IEEE P802.15
Wireless Personal Area Networks

Project	IEEE P802.15 Working Group for Wireless Personal Area Networks (WPANs)	
Title	TG3 SB1 text for various resolution	
Date Submitted	[8 February, 2003]	
Source	[James P. K. Gilb] [Apparent Technologies] [15373 Innovation Drive, #210, San Diego, CA 92129]	Voice: [858-485-6401] Fax: [858-485-6406] E-mail: [gilb@ieee.org]
Re:	[]	
Abstract	[This document is a summary of some of the more complex comment resolutions for SB1.]	
Purpose	[To provide a concise summary of comment resolutions that are too complex to represent in the comment database.]	
Notice	This document has been prepared to assist the IEEE P802.15. It is offered as a basis for discussion and is not binding on the contributing individual(s) or organization(s). The material in this document is subject to change in form and content after further study. The contributor(s) reserve(s) the right to add, amend or withdraw material contained herein.

1 **1. Text for selected resolutions**

29
30
31
32
33
34
35
36
37
38
39
40 **Figure 1—PNC sending the piconet services command to a newly associated DEV in**
41 **response to a request in the association proces.**

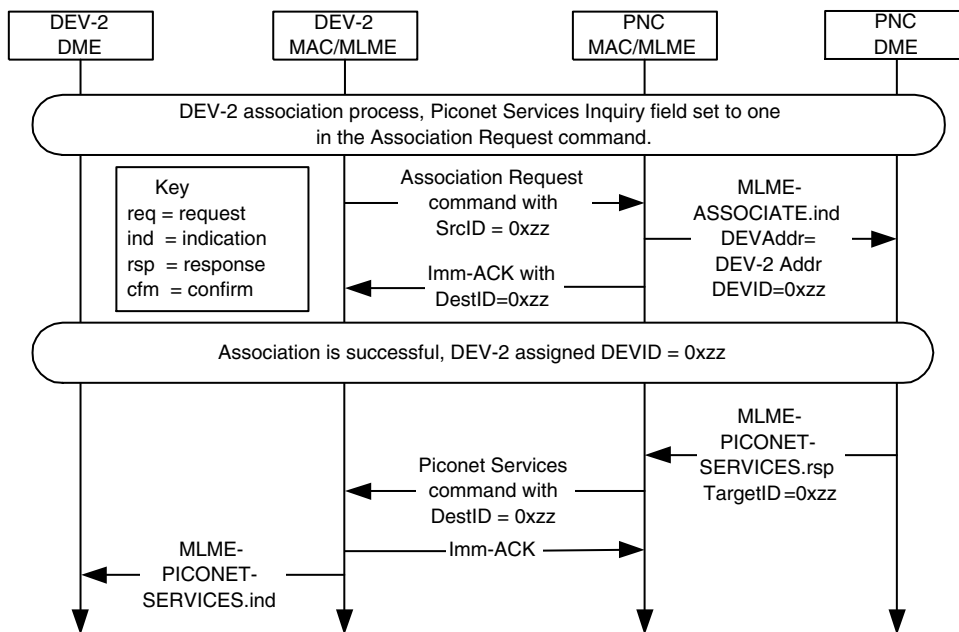
6
7 **1.1 CID 299**

8
9 Accept in principle “Change to ‘If the DEV sets the piconet services inquiry bit, the PNC shall send the
10 piconet services command, 7.5.4.6, with DestID set to newly assigned DEVID after that PNC has received
11 the second Association Request command from the DEV, {xref }. This process is illustrated in {figure xx},’
12 and add new MSC as shown in 03/032r10.”
13
14
15
16
17
18

Figure 3—MSC for the handing over control of a private, pseudo-static CTA

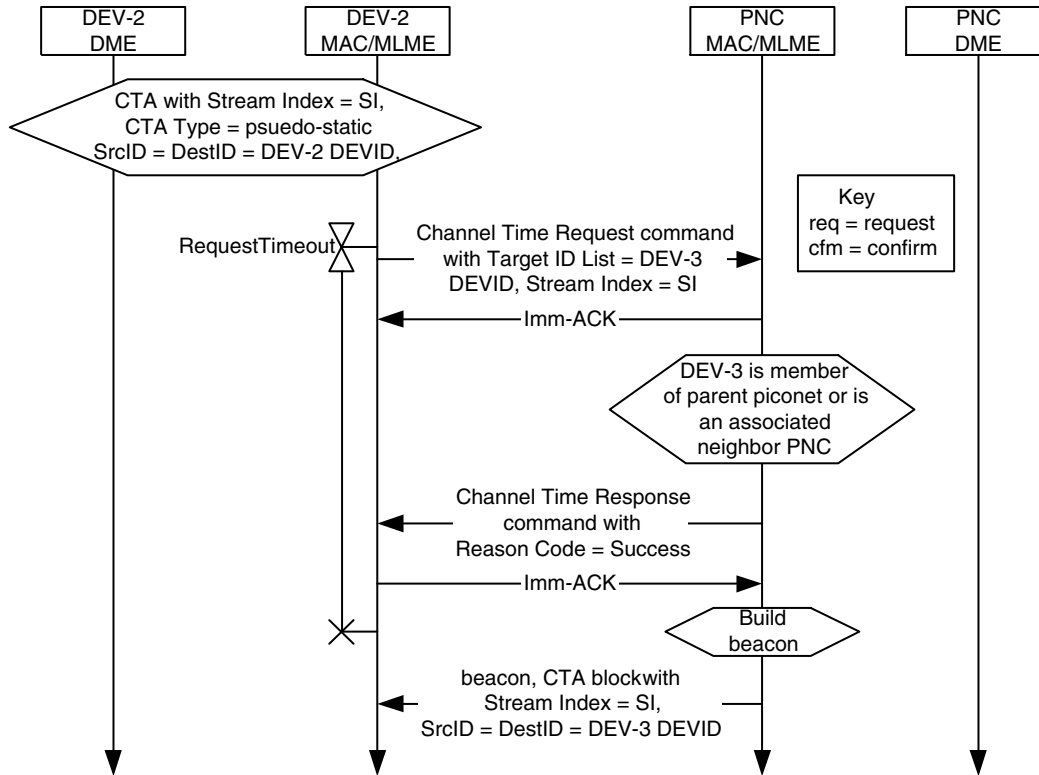
CID 1, CID 215, CID 352 and CID 139. Accept in principle “Add the ability to handover the dependent PNC as indicated in 03/032r8.”

The MSC for the handover of the control of a private, pseudo-static CTA is illustrated in Figure 3.

A dependent PNC, the originator DEV, may handover control of the dependent piconet's CTA to another DEV, the target DEV, in the parent piconet. The target DEV shall either be a member of the piconet or a DEV that has associated as a neighbor PNC, {xref association}. To handover control of the dependent piconet's CTA, the originator DEV shall send a Channel Time Request command to the parent PNC with the following parameters:

- The Num Targets field set to one.
- The Target ID List field containing the DEVID of the target DEV that is to receive control of the CTA
- The Stream Request ID set to zero.
- The Stream Index of a CTA that has already been allocated to the dependent PNC as a private, pseudo-static CTA.
- All other fields set to the same values as in the last successful Channel Time Request for this Stream Index.

If the target DEV indicated in the Target ID List is either a member of the parent piconet or is a associated neighbor PNC and the Channel Time Request command has the correct entries as indicated above, the parent PNC shall grant the request to change the source and destination for the stream and shall send a Channel Time Response command to the originator with the Reason Code set to 'Success'. The PNC shall continue to place the CTA block for the allocation in the beacon but shall change the SrcID and DestID to be equal to the target's DEVID. Once the PNC has changed the SrcID and DestID in the CTA block, the target DEV will have gained control of the CTA and will be allowed to request modifications or the termination of the allocation.

If the target DEV is not a member of the piconet and it is not an associated neighbor PNC, the parent PNC shall reject the request and shall send a Channel Time Response command to the originator with the Reason Code set to either 'DEV unassociated' or 'DEV unauthenticated' depending on the status of the Target DEV.

If the Channel Time Request command has improper entries, e.g. the Stream Index does not exist or the Stream Index is not associated with a private, pseudo-static CTA, then PNC shall reject the request and shall

send a Channel Time Response command to the originator DEV with the Reason Code set to 'Request denied'.

Figure 4—Successful PNC handover in a dependent piconet.

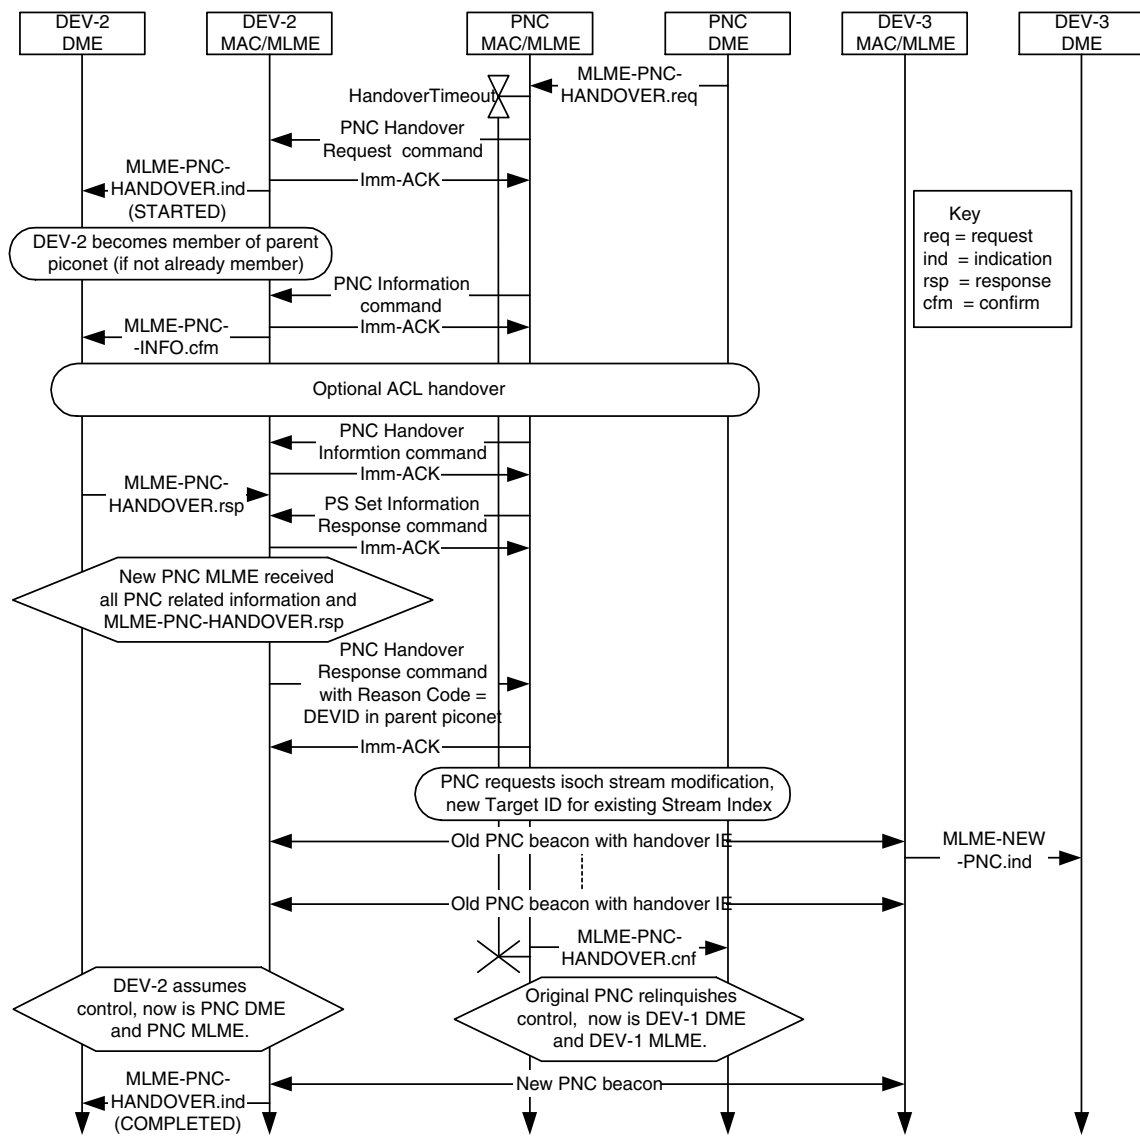
The dependent PNC handover process begins in the same manner as a regular PNC handover, {xref 8.2.3}, with the current PNC sending the PNC Handover Request Command to the target DEV that it has selected to

become the new PNC, as shown in Figure 4. In this and the two subsequent figures, the identities PNC, DEV-2 and DEV-3 are all relative to the dependent piconet and not the parent piconet. If the target DEV is not a member of the parent piconet, then that DEV shall begin the association process to join the parent piconet and, if required, authenticate with the parent PNC. The target DEV may request to associate with the parent piconet as either a neighbor PNC or as a member of the piconet. While target DEV is attempting to join the parent piconet, the current dependent PNC shall send the target DEV the information about all of the DEVs with the PNC Information command, all of the current channel time requests with the PNC Handover Information command and the power save information, if any, using the PS Set Information Response command. The target DEV may also request the transfer of any ACL data at this point using the ACL Information Request command. Note that the transfer of this information will not interfere with the target DEV's association and authentication process because the former occurs only during time reserved for the dependent piconet while the latter only occurs during time reserved for the parent piconet.

Once the transfer of the information is complete and target DEV has joined the parent piconet, the target DEV shall send a PNC Handover Response command to the dependent PNC with a Result Code set to the DEVID that was assigned to it by the parent PNC. This lets the dependent PNC know that the target DEV is ready take over control of the piconet. At this point, the dependent PNC shall send a Channel Time Request command to the parent PNC to handover the control of the dependent piconet CTA to the new dependent PNC, {xref 8.5.1.2 stream modification}. Once the parent PNC changes the SrcID and DestID of the dependent piconet CTA, the current dependent PNC shall either complete the handover process to the new PNC or it shall shutdown the dependent piconet because it will not be able to regain control of the CTA.

After the dependent PNC receives a beacon from the parent PNC with the change in the SrcID of the dependent piconet CTA, the current dependent PNC shall begin placing the Handover IE in its beacon with a countdown to indicate the last superframe that it will be the PNC using the procedure indicated in {xref 8.2.3}. The last superframe controlled by the current dependent PNC will be the one in which the Handover Countdown field is zero. The following superframe will begin when the target DEV, now the new dependent PNC, sends its first beacon.

Figure 5—Failed dependent PNC handover when target DEV fails to join parent piconet.

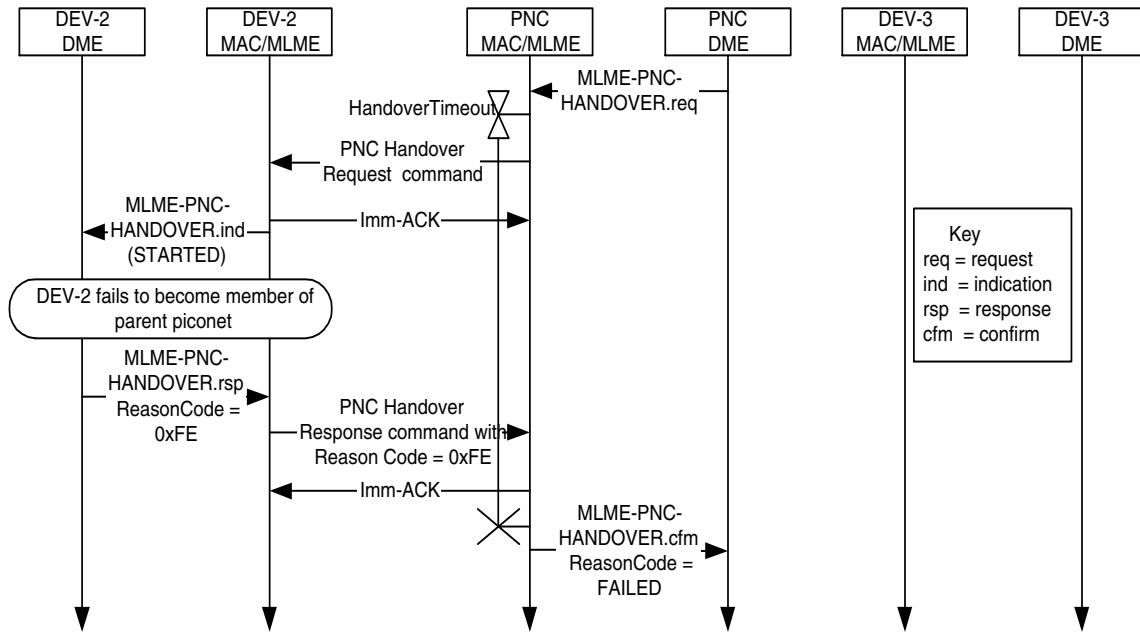
If the target DEV fails to join the parent piconet as either a regular DEV or as a neighbor PNC, it shall send the PNC Handover Response command to the dependent PNC with the Reason Code set to 'Handover

refused, unable to join parent piconet' as illustrated in Figure 5. The target DEV may refuse the handover at any time while the dependent PNC is sending over the information about the piconet.

Figure 6—Failed dependent PNC handover when control for the dependent piconet CTA is handed over in the parent piconet.

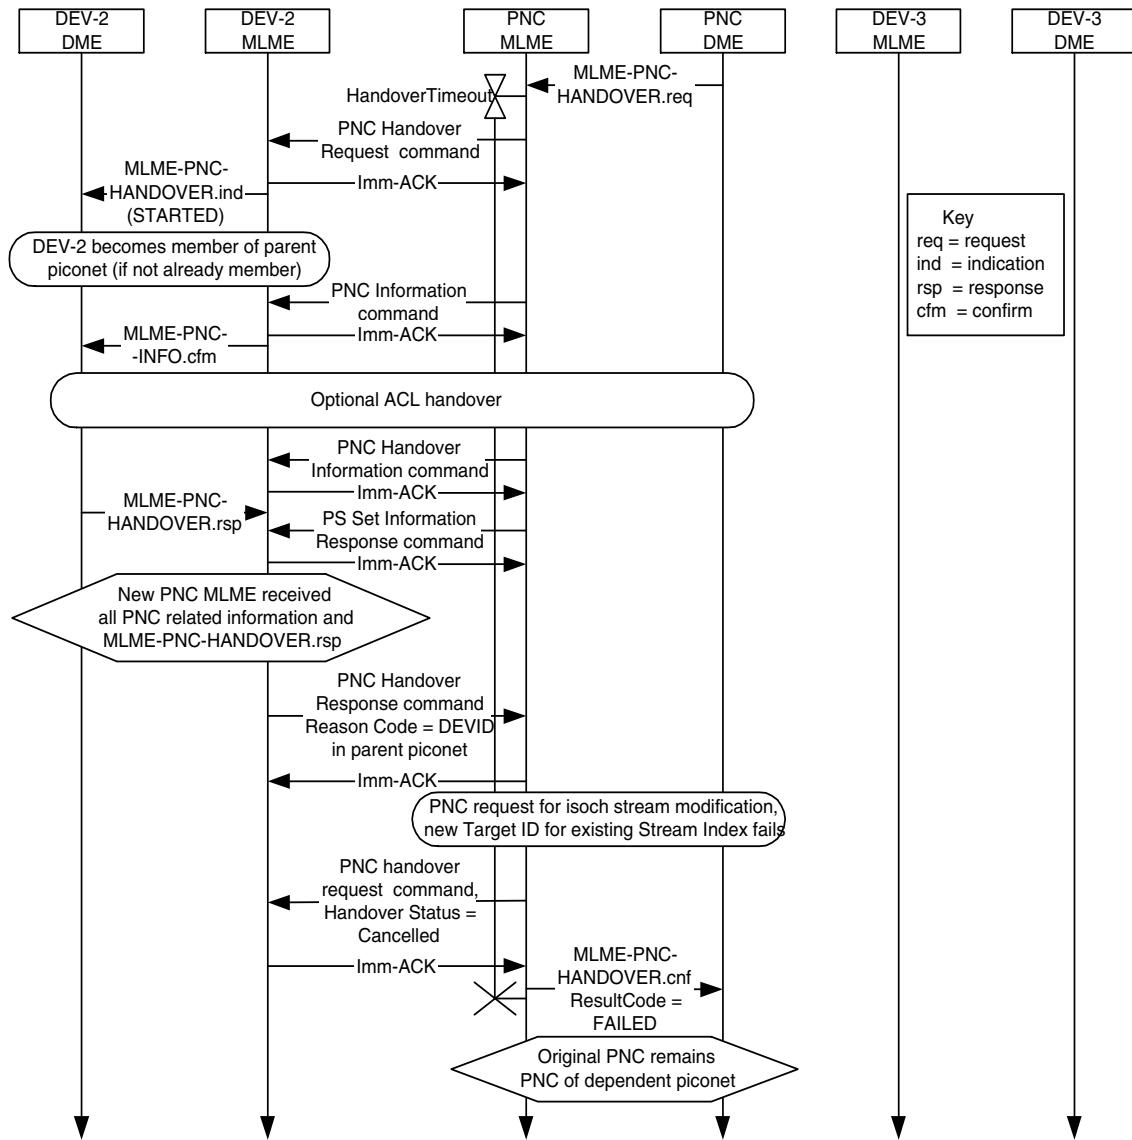
If the parent PNC rejects the request to handover control of the CTA to the new dependent PNC, the dependent PNC shall send a PNC Handover Request command to the target DEV with the Handover Status field set to 1 to indicate that the handover process is being cancelled, as illustrated in Figure 6.

If the dependent PNC cancels the handover process, the target DEV may disassociate from the parent piconet. If DEV-2 joined the parent piconet as a neighbor PNC, it should disassociate from the parent piconet if the handover process is cancelled to free up that resource for other DEVs that may want to form a neighbor piconet.

Figure 7—Channel time request for frames with immediate ACKs

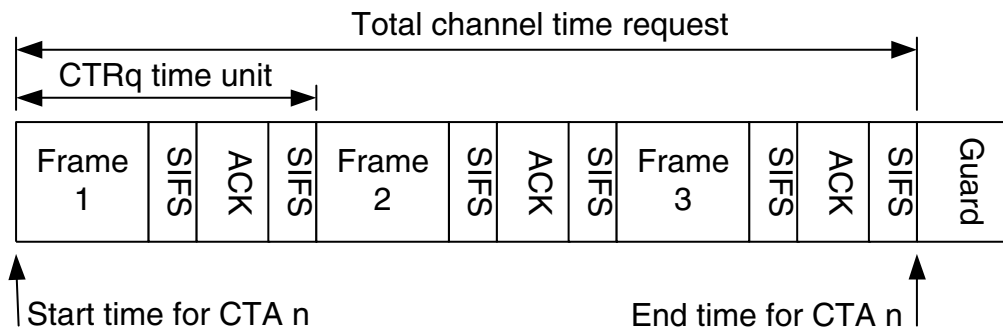
Accept in principle: “The inclusion of MIFS changed the CTR calculations, but the changes were not reflected in 8.4.4.6. ‘1) Change b3 in Figure 79 from “stream termination” to “MIFS CTRq TU”. 2) Replace page 152, line 12 with:

The requesting DEV shall include the frame transmission time, if known *a priori*, and the ACK transmission time, if used, and MIFS or SIFS time as appropriate per frame or ACK when calculating channel time requests. Figure 7 (was #108) shows an example of channel time being requested for a CTA where Imm-ACKs are used.

Figure 8—Channel time request with no ACKs

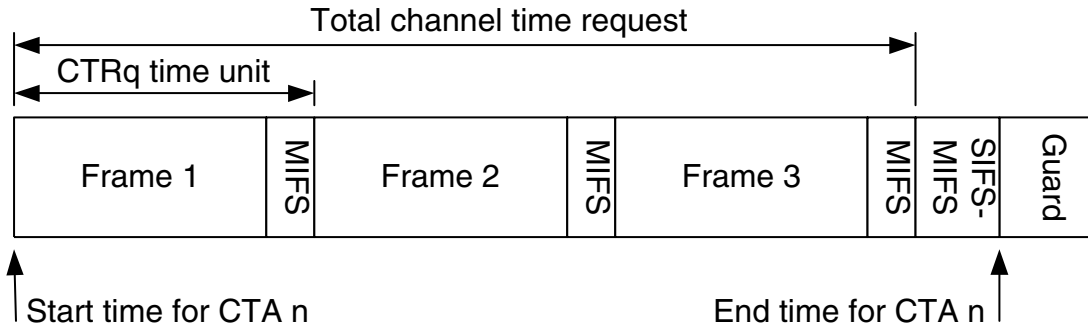
When No-ACK is used, the channel time request is calculated differently because there is a MIFS in between each frame in the CTA instead of a SIFS. A channel time request that uses a CTRq TU with MIFS instead of SIFS shall set the CTRq TU MIFS bit to one to inform the PNC that it must add a time equal to SIFS-MIFS to the end of the CTA. This ensures that there is a SIFS between the end of transmission in one CTA and the

start of the next. Figure 8 shows an example of a channel time request when no-ACK is used and the MIFS bit is set in the Channel Time Request command.

Figure 9—CTRq time unit covering multiple frames with CTRq TU MIFS = 0

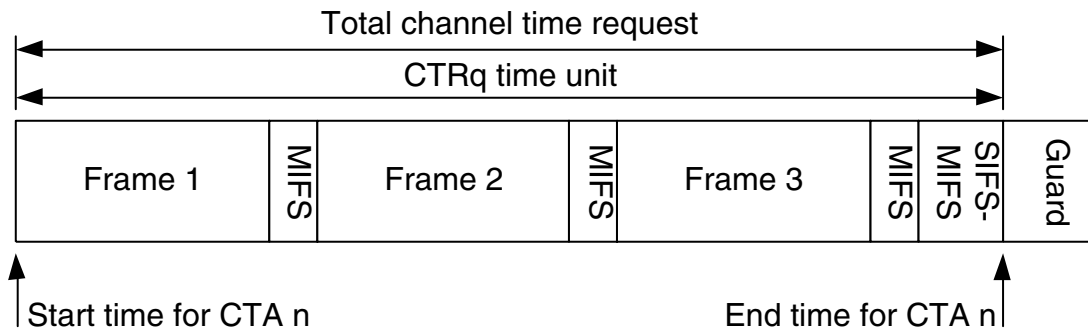
A CTRq TU in the CTA may cover more than one frame as shown in Figure 9. If the requesting DEV included SIFS-MIFS following the last MIFS as shown in Figure 9 it shall set the CTRq TU MIFS in the Channel Time Request to “0.” IF SIFS-MIFS is not included in the CTRq TU, the CTRq TU MIFS bit shall be set to “1” and the PNC shall add SIFS-MIFS to the CTRq TU to calculate the duration of the CTA. Figure 9 shows a multi-frame CTRq with the CTRq TU MIFS field set to 0.

Figure 10—CTRq time unit covering multiple frames with CTRq TU MIFS = 1

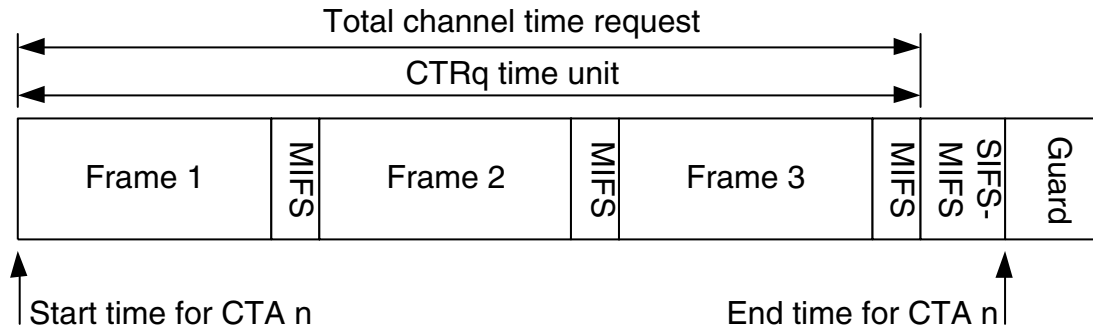
Figure 10 shows a multi-frame CTRq with the CTRq TU MIFS field set to 1.
